Poplar Grove: Sketch Plan No. 320180220

Poplar Grove: Sketch Plan No. 320180220: Application for up to 1,206,000 square feet (1.02 FAR) of development, including up to 686,000 square feet (0.58 FAR) of residential (including a minimum 12.5% MPDUs), and up to 520,000 square feet (0.44 FAR) of commercial uses on 19.41 acres of net lot area located on the east side of Century Boulevard between Father Hurley Boulevard and the future Dorsey Mill Road; CR 2.0, C-1.75, R-1.0, H-145T and Germantown Transit Mixed Use Overlay Zone; 2009 Germantown Employment Area Sector Plan.

Recommendation – Approval with conditions

Figure 7 – Block J options

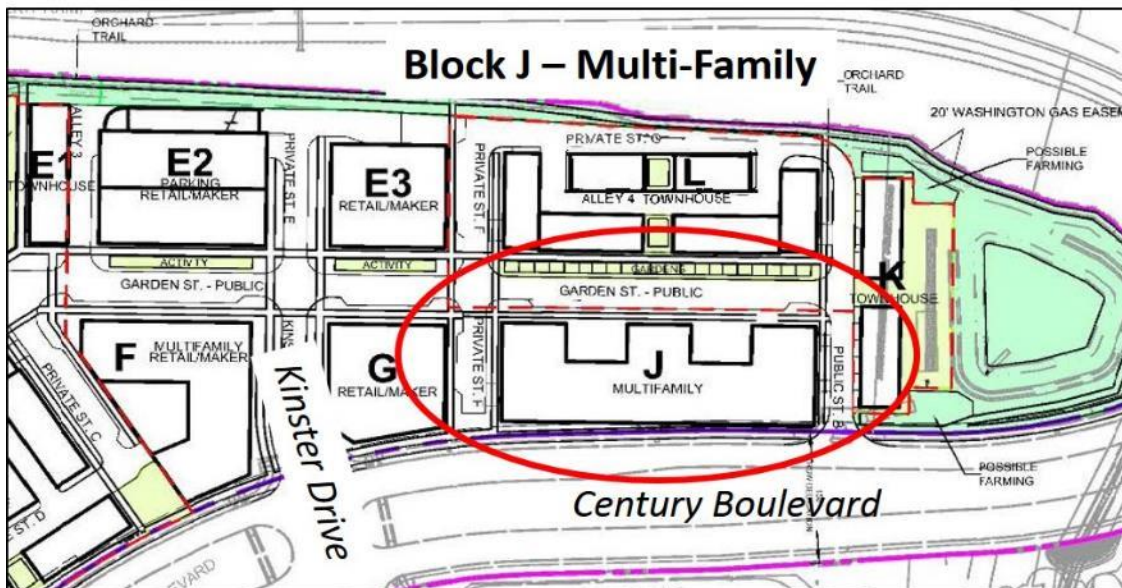
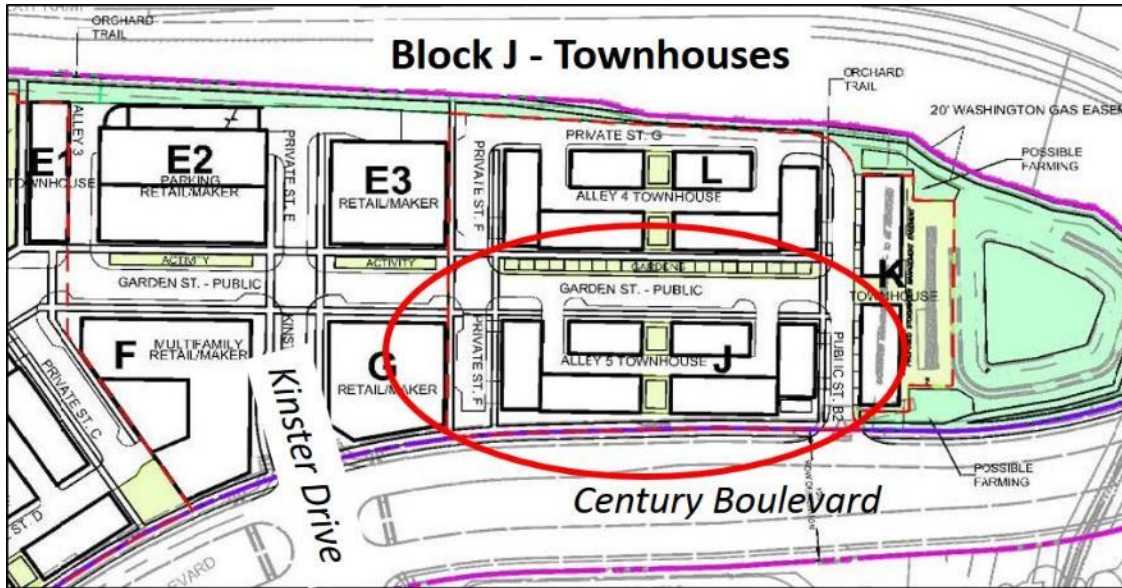
- a. Prior to Preliminary Plan approval for Block J, the Applicant must choose between either townhouse or multi-family development.
- b. At the time of each site plan approval, the Applicant must submit the necessary documentation showing how the plans satisfy the Zoning Ordinance and Incentive Density Implementation Guideline requirements, including meeting the following phased criteria:

The Sketch Plan Application is divided into a series of blocks, and proposes two alternatives for development for the residential uses on what is identified as Block J; developed as either townhouses or multi-family housing. Illustrating this request, Figure 6 (above) has been modified to show the building use as both residential mixed-use and residential townhome. The Applicant however is not proposing retail for Block J, so if developed as the multi-family option, it would be an all residential building. The townhouse alternative is shown in plan view in the top of Figure 7, showing how the layout of Block J would be similar to townhouse block L, with townhouse units facing the proposed public and private streets, with central courtyards and a service alley in the middle of the block. The bottom of Figure 7 shows a plan view of Block J as a multi-family building that would fill the entire block with building but would generally keep the public and private road network the same. Both options have been reviewed by Staff as part of the review of the Sketch Plan and the Applicant has provided all plan documents showing both alternatives.

Figure 11 – Proposed Street Layout

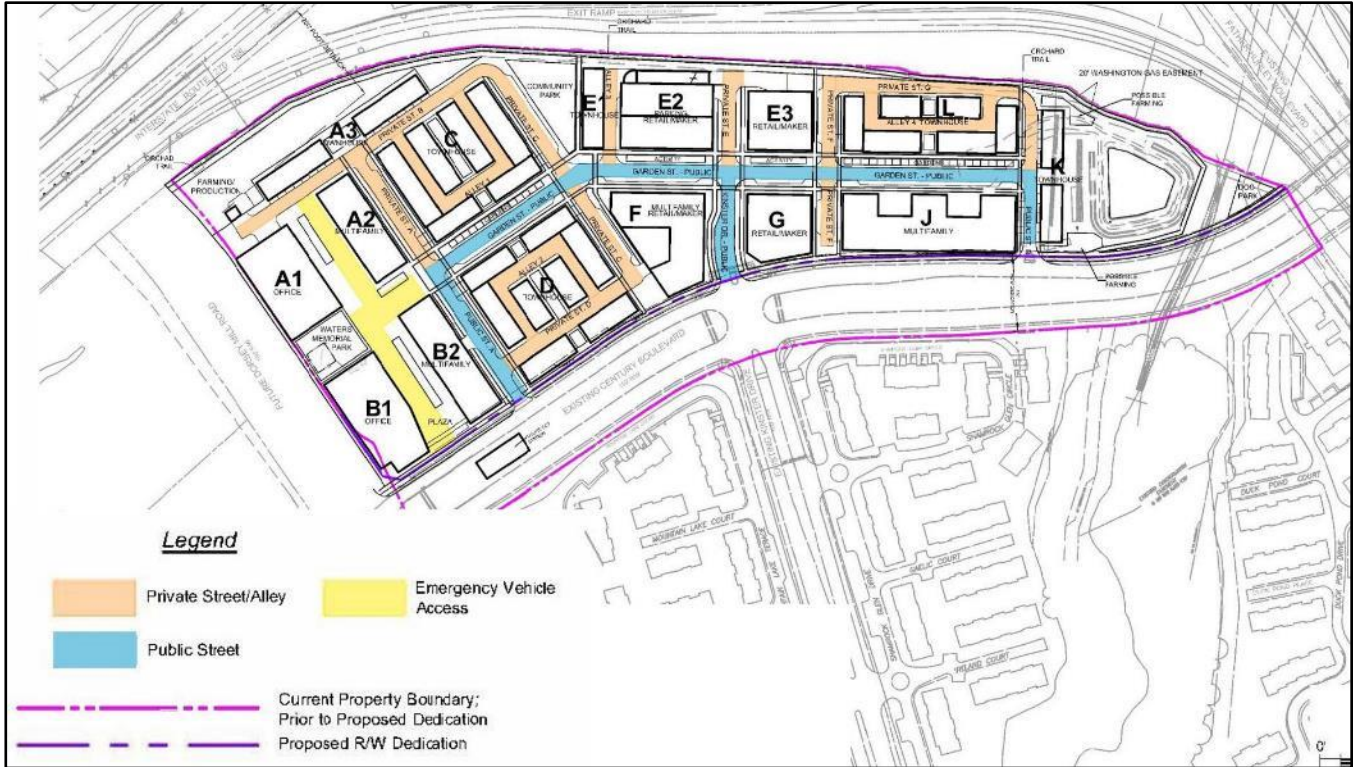
- a. Submit a design exception package including the necessary cross-sections and justifications for approving the Garden Street, Public Street A, Public Street B2, and Kinster Drive as public streets

- b. Provide the appropriate justification to Staff, including anticipated road cross-sections and construction standards, for all other streets shown on the Sketch Plan as private.
- c. Complete the dedication of approximately 7.74 acres to complete the right-of-way for Century Boulevard.

Vehicle circulation proposed by the Sketch Plan consists of a mix of both public and private streets (Figure 11). The proposed public streets include The Garden street, and the three streets that access Century Boulevard. The streets and alleys that will serve as internal access to the townhouse development areas are proposed to be private. The Property is adjacent to freeway ramps to the east and abuts unfavorable grades to the north, resulting in the modified grid pattern that is proposed, only providing access to Century Boulevard. The large plaza shown in the Mixed-Use Transit district will generally be closed to private vehicles but will be designed to accommodate emergency vehicle access. Parking and loading for these structures will need to be located in underground garages.
